**TOWN OF ESSEX
PLANNING COMMISSION
AMENDED AGENDA
DECEMBER 9, 2021-6:30 P.M.
MUNICIPAL CONFERENCE ROOM,
81 MAIN ST., ESSEX JCT., VT**

ESSEX PLANNING COMMISSION

137 Towers Road – Major Subdivision and Residential Planned Unit Development (PUD-R) (Sketch)

OVERALL PROPERTY PLAN

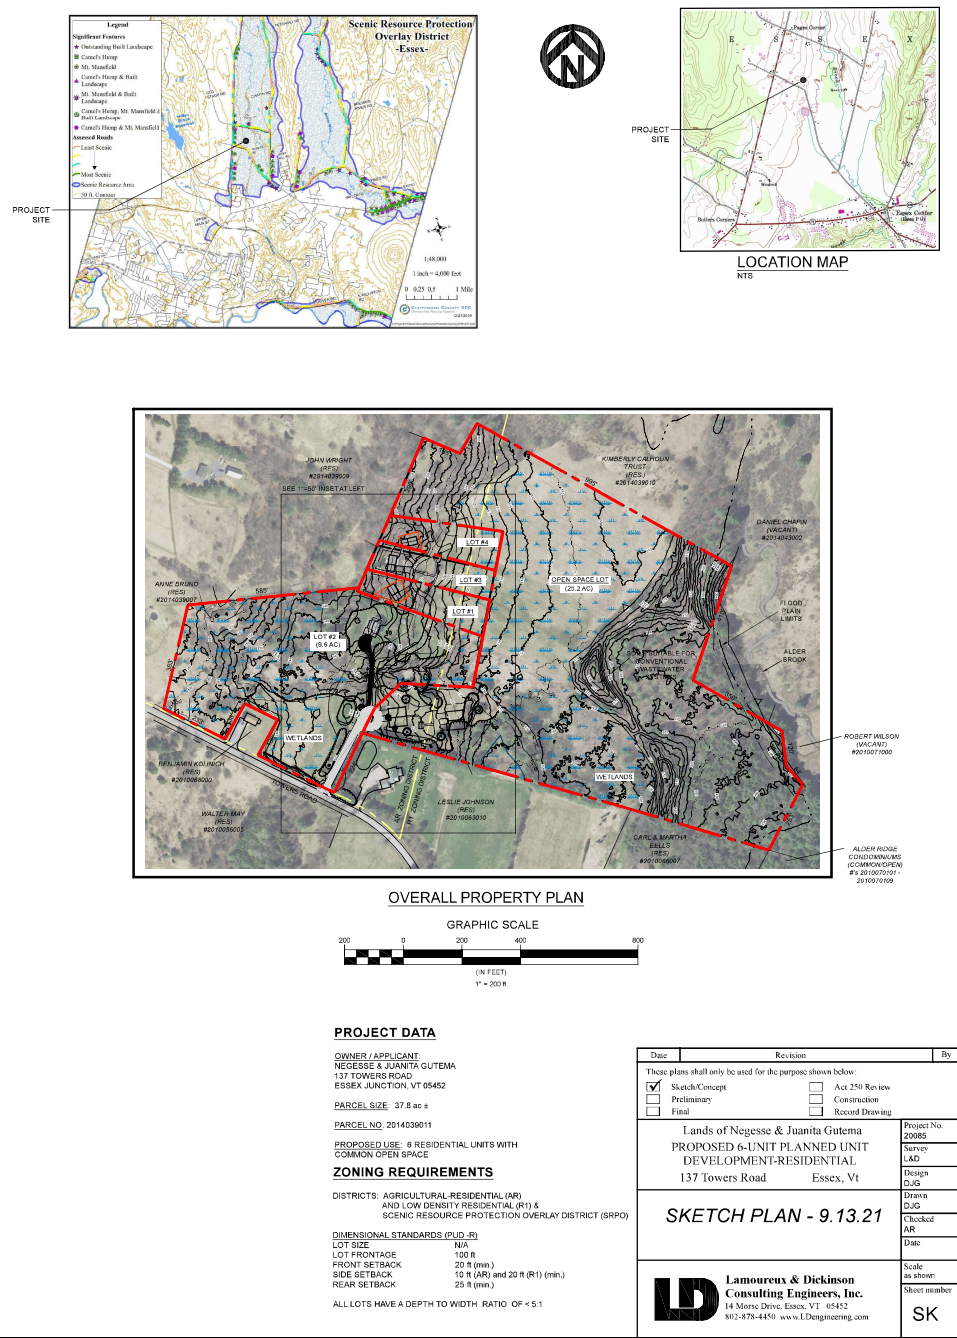
- a) *Public Works understands that the proposed PUD will utilize the existing curb that currently provides access to the applicant's home. Due to the significant change and proposed increase in use, a Town curb cut permit will be required for approval.*
- b) *Public Works takes no exception to the private access road as proposed but the design and construction of this road shall adhere to the requirements of the Town of Essex Standard Specifications for Construction.*
- c) *It appears that the driveway serving Lots 1-4 will be constructed to the standards of Detail A-11. Due to the length of this drive, Public Works recommends continuing the 20' wide cross section to the end of the drive and turn around. Public Works will defer further comment to the Town of Essex Fire Department to determine if the length or width of the drive can support emergency vehicles.*

In an e-mail dated November 19, 2021 the Fire Chief objected to the design of the driveway serving Units 1-4 because it would not provide sufficient width for fire trucks to pass when shuttling water, which is required because there is insufficient water available for firefighting at this location. At minimum, the driveway must be 20 feet wide for the entire length, including the turn-arounds at the end; based on the National Fire Protection Association's Standard 1141, the Fire Chief recommends that the access drive be 24 feet in width, or that the homes be sprinklered to ensure adequate fire suppression is available.

- b) *Although not mentioned specifically, it is assumed that each of the new housing units will be served by an onsite by a community or individual well. Public Works has concerns regarding the potential yields of the proposed wells and the ability of onsite water to appropriately provide water on a consistent basis.*

- a) The entire length of the shared driveway (including turn-arounds) serving Units 1-4 shall be widened to 20 feet
 - b) An 8-inch municipal water line extension along Towers Road shall be added, with lines serving each dwelling which meet the requirements of the Town's *Standard Specifications for Construction*
